Service Update

18218 Propeller Shaft Disengage at Power Transfer Unit

Reference Number: N182162920

Subject: 18218 - Service Update
Propeller Shaft Disengaged at Power Transfer Unit

5116259

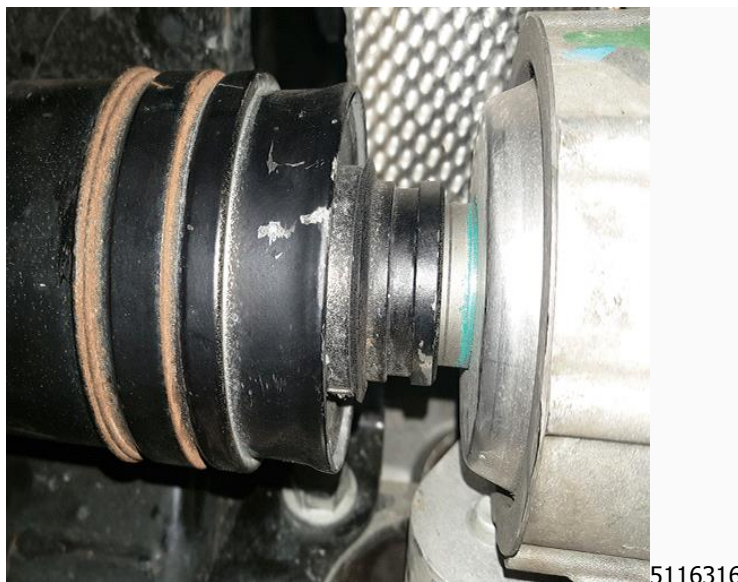
2. Using both hands, push forward firmly on the driveshaft several times as shown to ensure it is snapped into the Power Transfer Unit (PTU) fully.

3. The driveshaft-to-PTU interface should look as shown when the driveshaft is fully seated. Repeat step 2 as necessary until the driveshaft is fully engaged in the PTU as shown. If you pull on the driveshaft at this point, there should be no movement.
4. Lower the vehicle. Refer to *Lifting and Jacking the Vehicle* in SI.
